PROJECT: Sumter Town Green

PROJECT #: 0649B

ADDENDUM NO. 1 – January 10, 2014

RECYCLED ASPHALT SECTION DETAIL

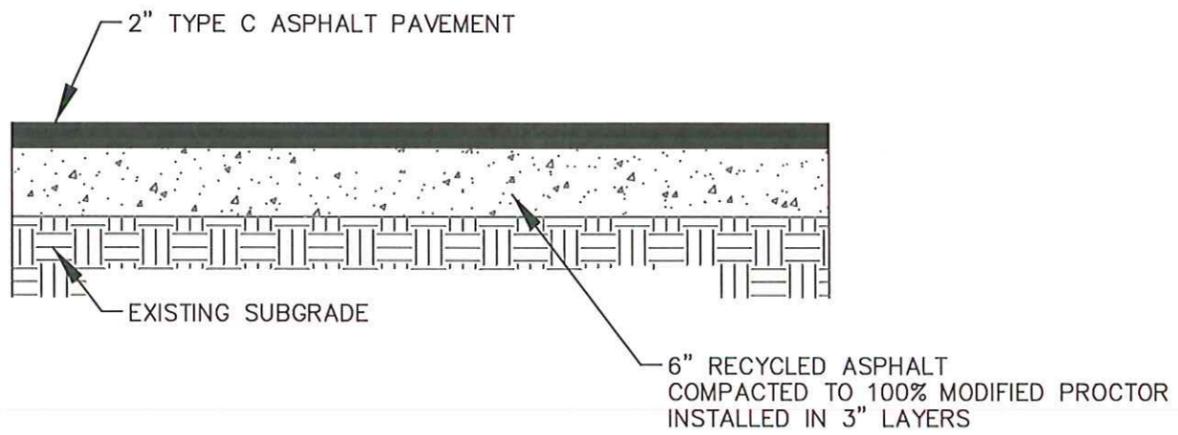
On sheet 18- Details:

See the attached revised Recycled Asphalt Section Detail that shows the asphalt installed in 2-3” layers.
